Development Review Committee

Re: <u>Trailside Townhomes – Site Plan and Plat Amendment Request</u>

Application No.:	SPR-58-2022 and SUBD-111-2022
Applicant:	John Wheatley, representing IKON Development
Project Location:	2142 East Brookings Dr.
Current Zoning:	RR-22 (Rural Residential), RR-43 (Rural Residential), and RM (Multi-
	family) Zone
Acreage:	19.37 Acres (Approximately 843,757 ft ²)
Request:	Request for approval of a Site Plan and Plat Amendment in the
	RR-22 and RR-43 zones in order to develop the vacant property
	with 152 townhomes.

CAUTION: NOTICE TO CONTRACTOR

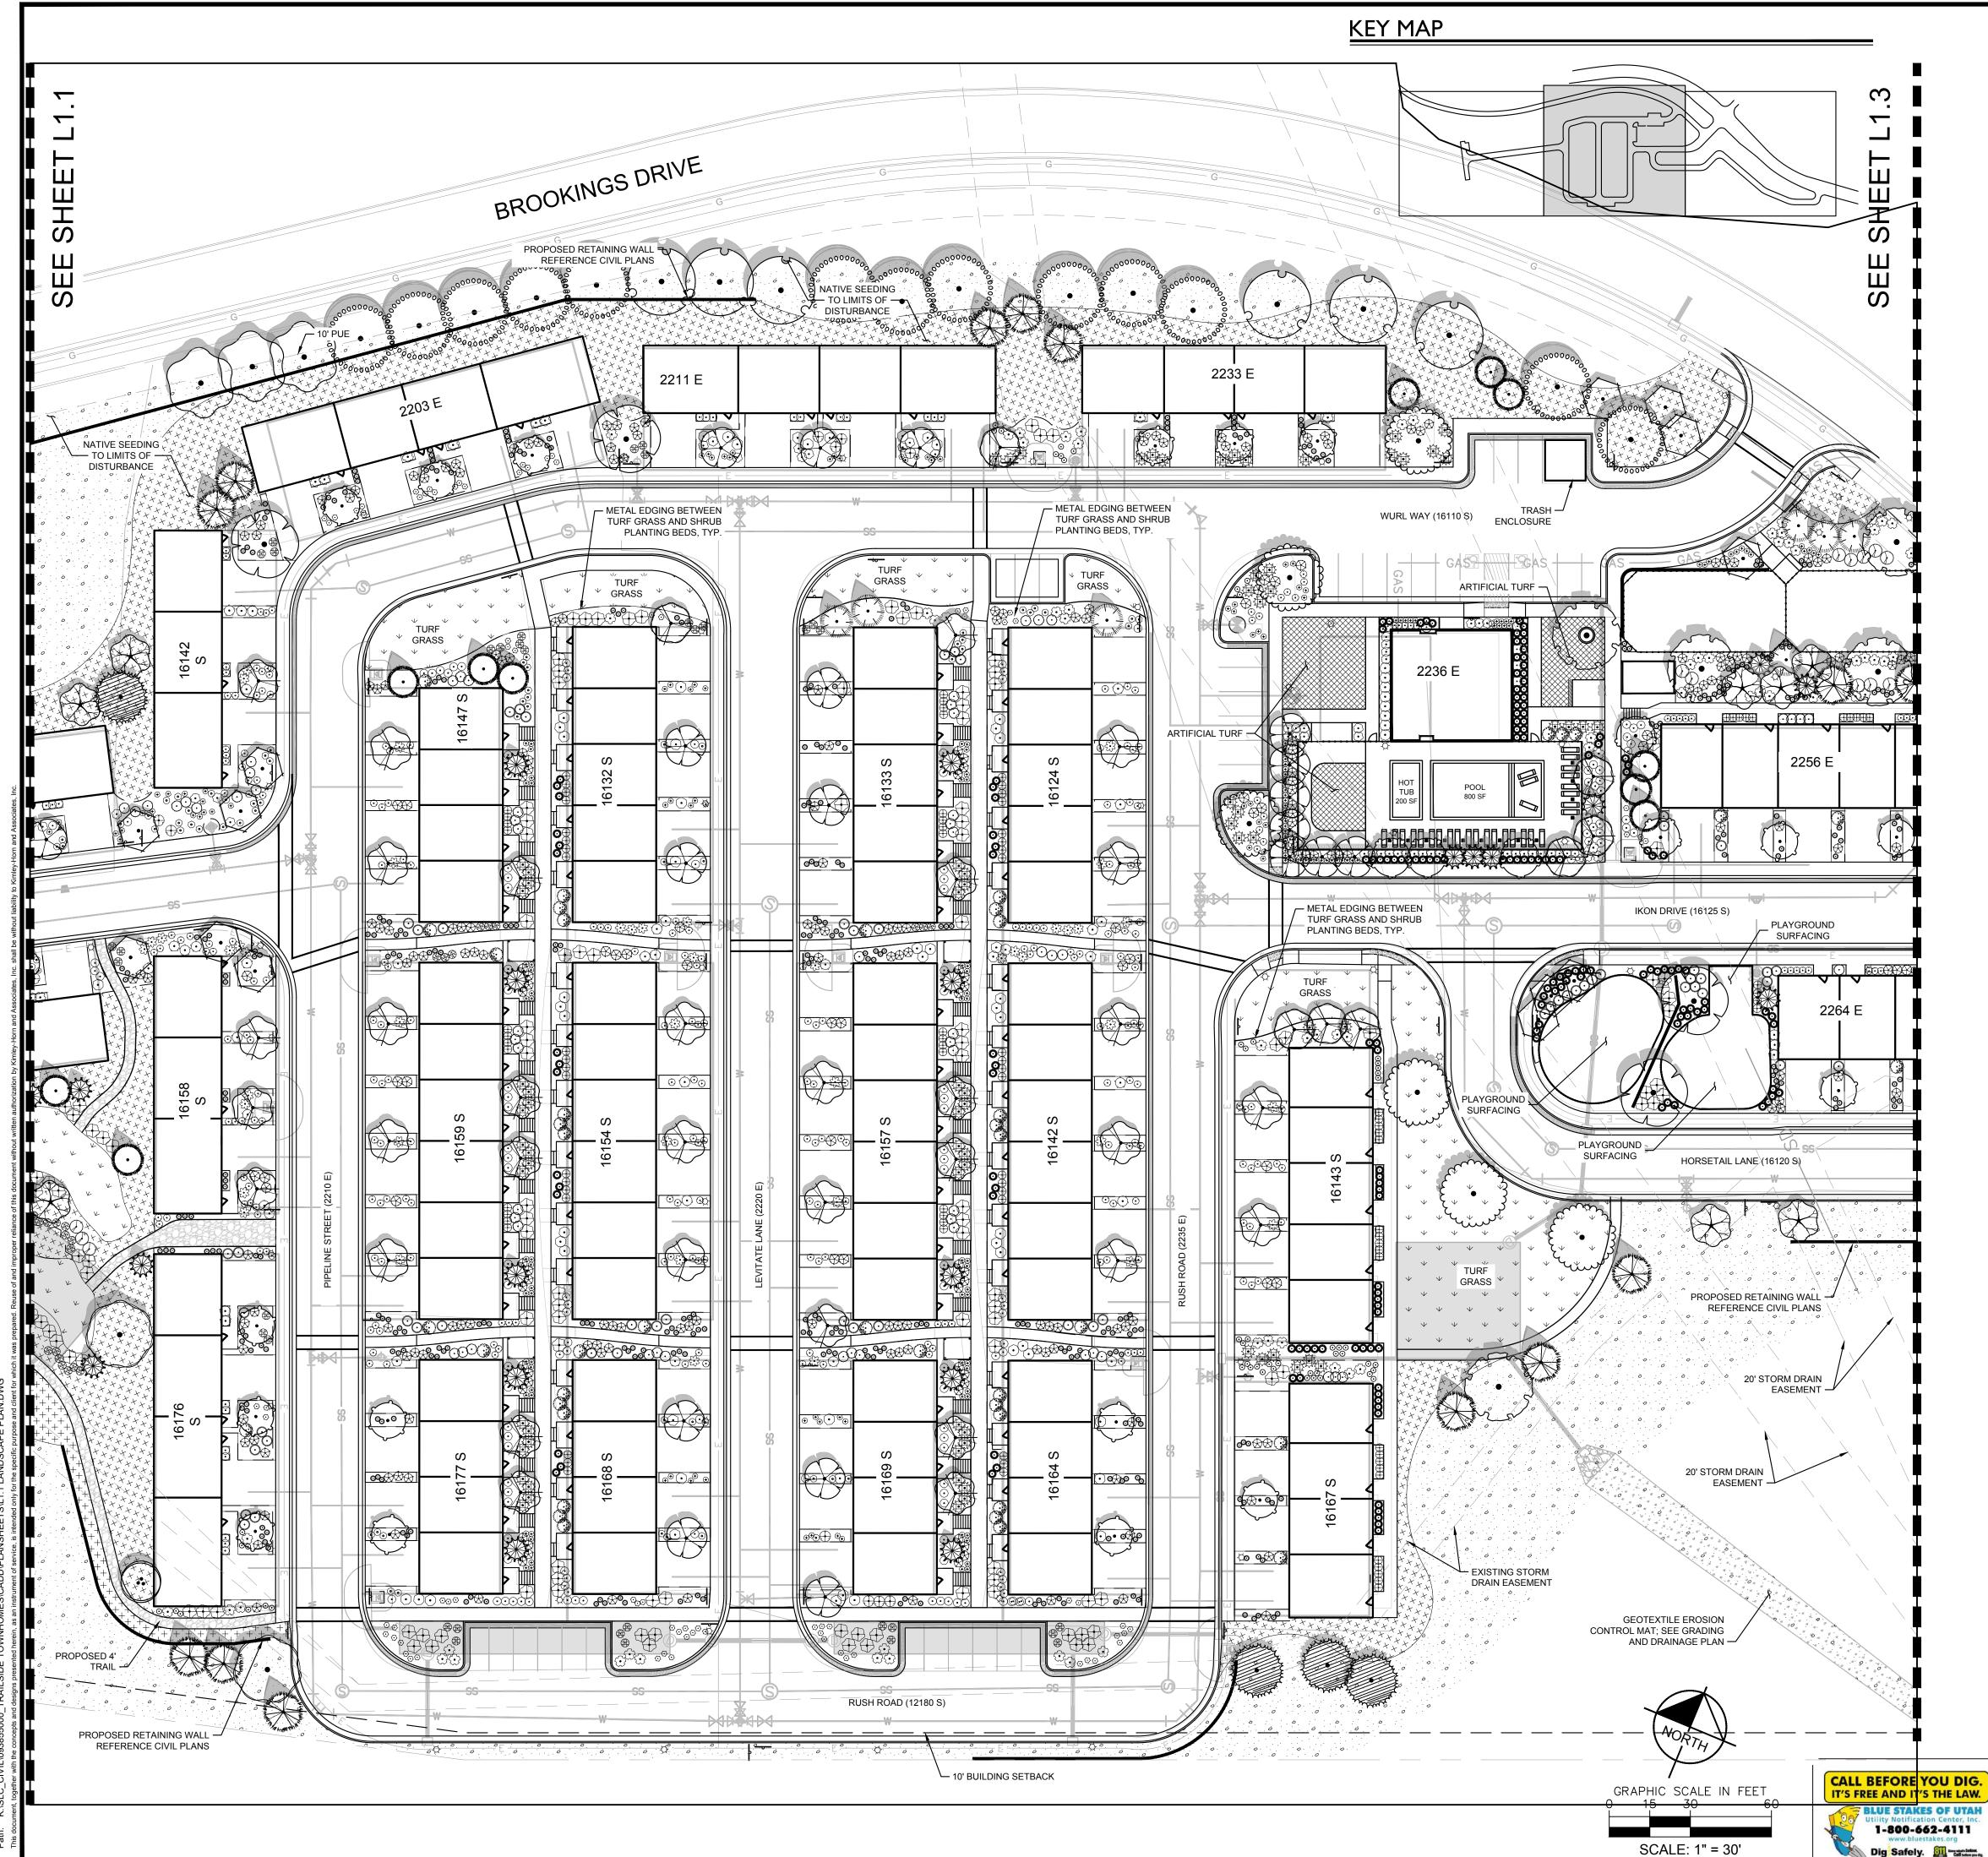
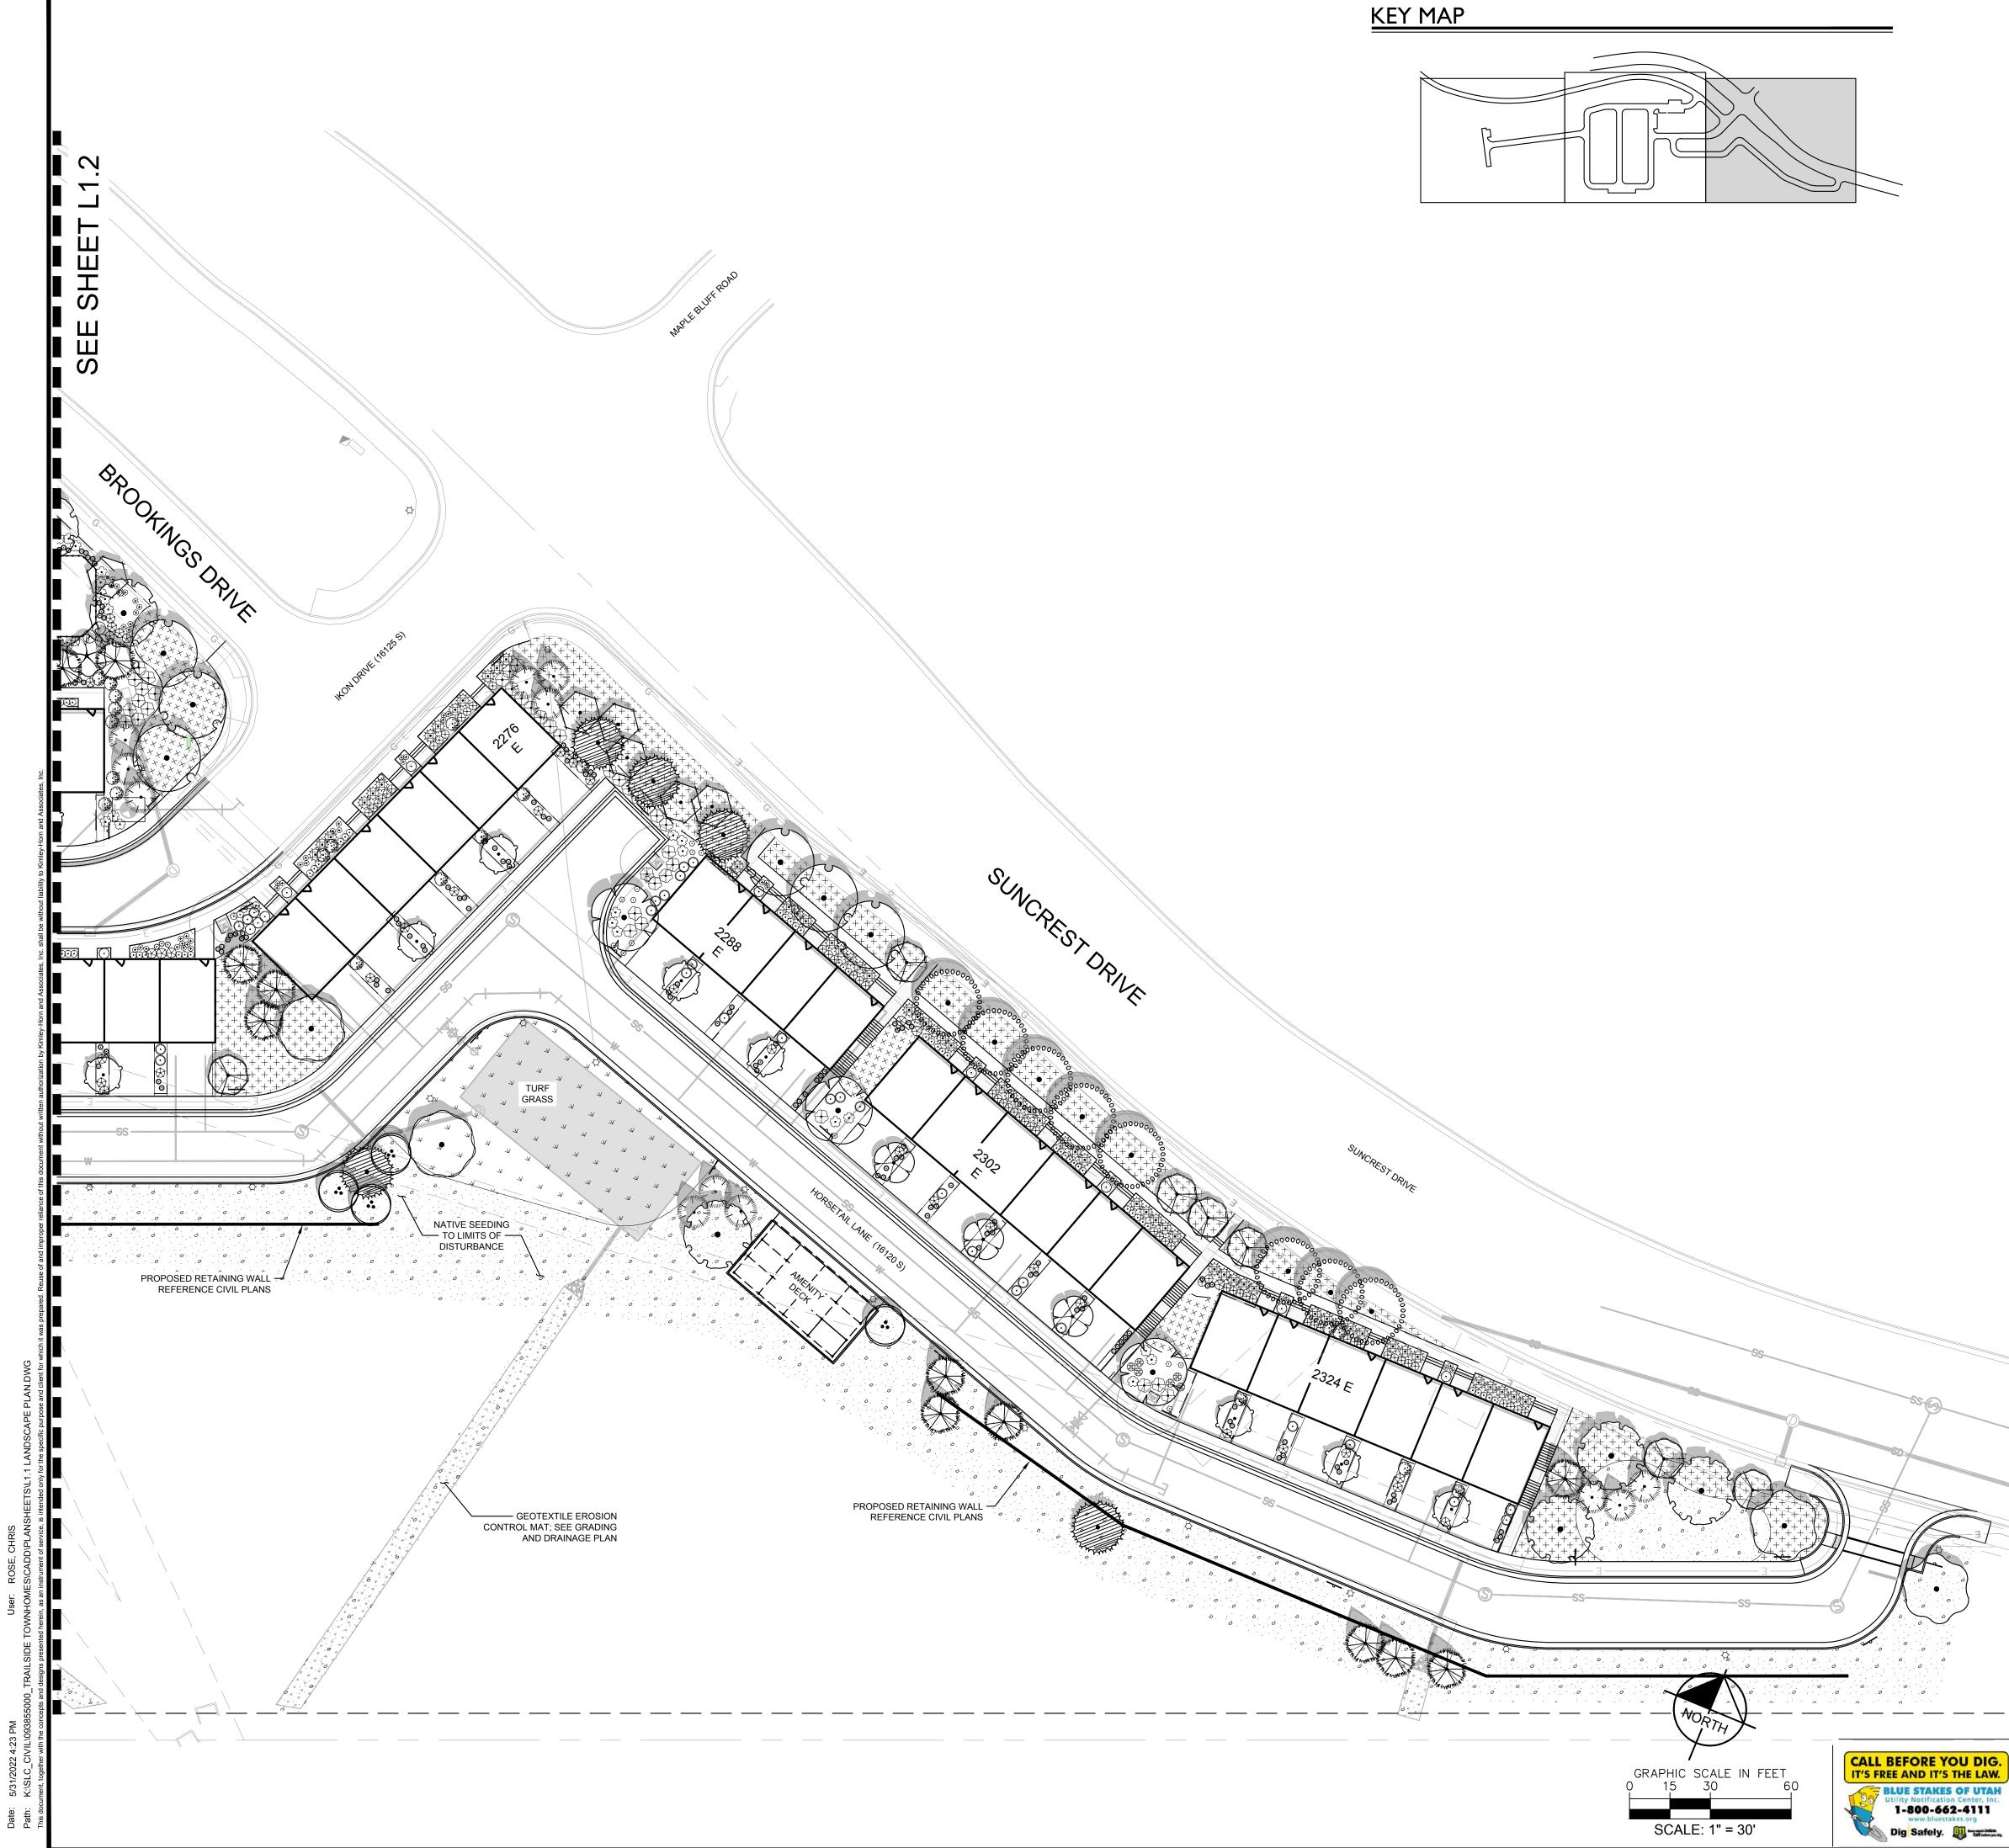
Landscaping and Lot Coverage. The landscape plan includes substantial natural open space, about 2/3rd of the property will be in natural open space (Exhibit G). The other 1/3rd will be made up of amenity space and landscaped areas adjacent to buildings. Amenities provided include a clubhouse, pool, hot tub, tot lot, picnic areas, and view decks.

Table 5	Landscaping Design Requirements			
Standard	DCMC Requirements Proposal Notes			
Lot Coverage	40% Max	29.8%		
Overall Landscaping Coverage	30% Min	34%		
Buffer Landscaping	NA	NA		
Water Wise Landscaping	NA	The majority of the property is in native grasses.		
Street Trees	From approved tree list	Not all listed trees are from approved list	Changes required	
Amenities	5 required	7 provided

- A. Update the tree plat list so that all trees located on a street are from the approved Draper Street Tree list.
- 3. Prior to Land Disturbance Permit issuance, amend civil plans to address all outstanding comments:
